Access Compliance Report

Public Rights-of-Way

(Curb Ramps)

Intersection ID: 19024	Main Street: CAVENDISH_CT	Cross Street: PROVIDENCE_RD	Location: NW
ADA ID: 6DA9E987C23F	Ramp Type: ParaDiag	Initial Pass/Fail: Fail	Overall Compliance: No
Severity Score: 31.25			
Codes/Mitigation Info/Possible Solution		Field Measurements/Component Compliance

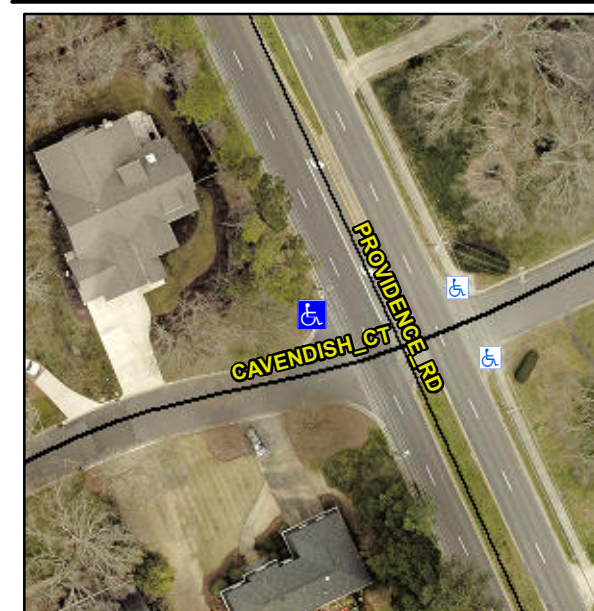
MEDIAN ACROSS PROVIDENCE RD

R304.5.1, R304.5.3, R304.3.2

Compliance	Description	Data	Compliance	Description	Data
N/A	Ramp Length LT (in)	57.0	N/A	Ramp Length RT (in)	54.0
No	Ramp Width LT (in)	33.5	No	Ramp Width RT (in)	34.0
Yes	Ramp Slope LT (%)	3.9	No	Ramp Slope RT (%)	11.6
No	Ramp XSlope LT (%)	2.7	No	Ramp XSlope RT (%)	3.1
N/A	Landing Length (in)	N/A	N/A	DWS Provided?	N/A
N/A	Landing Width (in)	N/A	N/A	DWS Contrast?	N/A
N/A	Landing Slope (%)	N/A	N/A	DWS Length (in)	N/A
N/A	Landing X Slope (%)	N/A	N/A	DWS Full Width?	N/A
N/A	Landing Curb? (Y/N)	N/A	N/A	DWS Offset (in)	N/A
N/A	Shared Landing?	N/A			
N/A	Gutter Ponding?	N/A	N/A	Gutter Slope (%)	N/A
N/A	Gutter Lip Ht (in)	N/A	N/A	Gutter X Slope (%)	N/A
N/A	Painted X Walk1?	No	N/A	Painted X Walk2?	No
	X Walk 1 Direction	To S		X Walk 2 Direction	To E
N/A	X Walk 1 Width (in)	N/A	N/A	X Walk 2 Width (in)	N/A
	X Walk 1 Slope (%)	4.4		X Walk 2 Slope (%)	11.8
	X Walk 1 X Slope (%)	11.8		X Walk 2 X Slope (%)	1.7
N/A	Ramp inside XWalk1?	N/A	N/A	Ramp inside XWalk2?	N/A

Remove & Replace Curb Ramp With Two New Directional Ramps or Equivalent.
